Re: Correction for Seepage Estimate Methodology - Sand Rock Mill  
Project - NRC Docket No. 40-8743

CALCULATION SHEET FOR SEEPAGE

FIGURE 5-7. (updated 5/81) ESTIMATED SEEPAGE FROM THE EVAPORATION POND WITH CUTOFF TRENCHES IN THE UPPER SANDSTONE

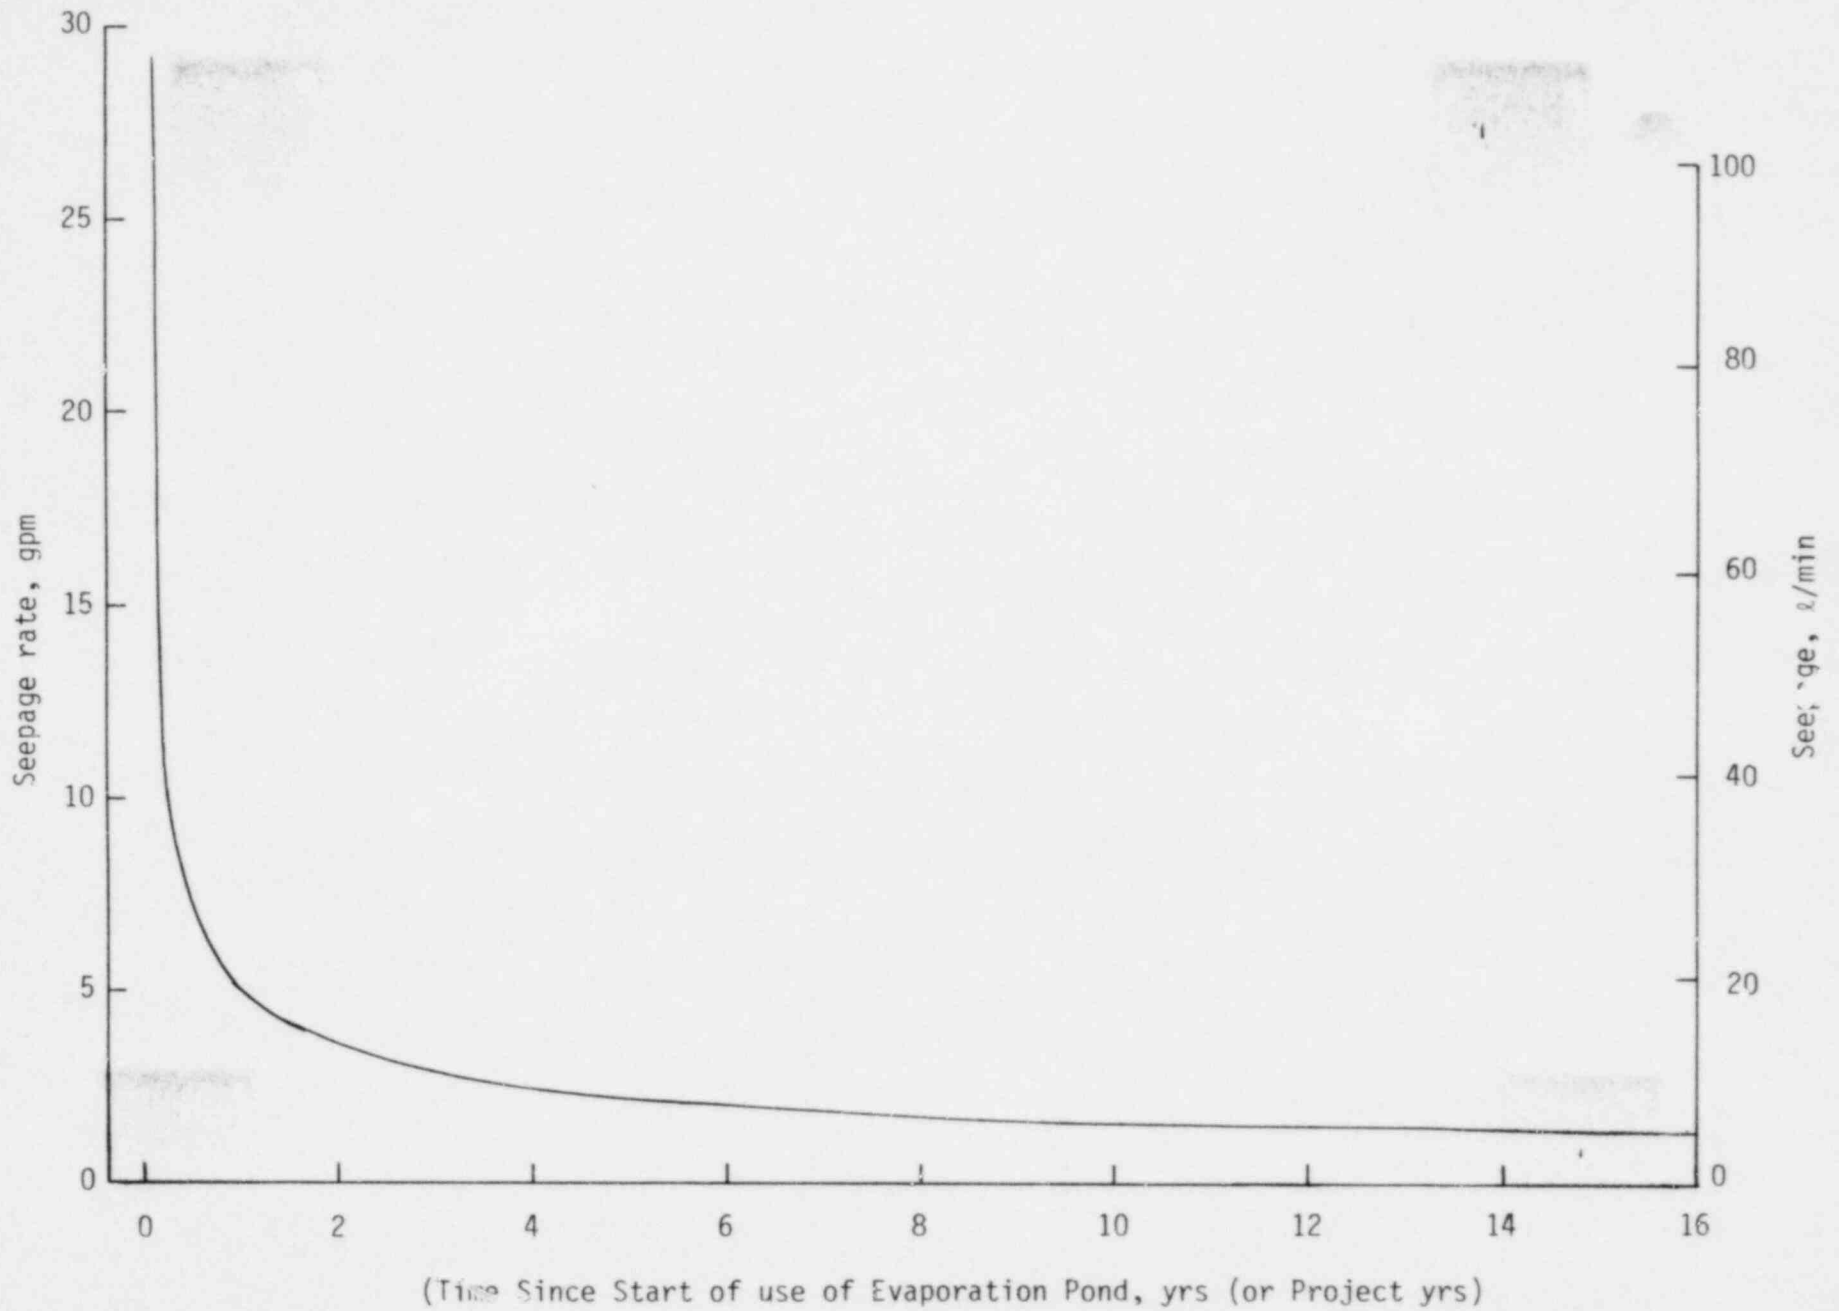
As noted by the NRC consultants, we did use the total area of the evaporation pond for  $R^2$  in our seepage calculations when we should have used the total area divided by  $\pi$ . We have recomputed the seepage rate for the proposed alternative (cutoff trenches in the Upper Sandstone) with the correct  $R^2$ .

A corrected Figure 5-7 of the E.R. is included. Very little difference in the seepage rates was obtained by the change in the  $R^2$  value. The parameters used in the calculation and the seepage values are given on the enclosed calculation sheet. This sheet should aid the reviewers in checking our calculations.
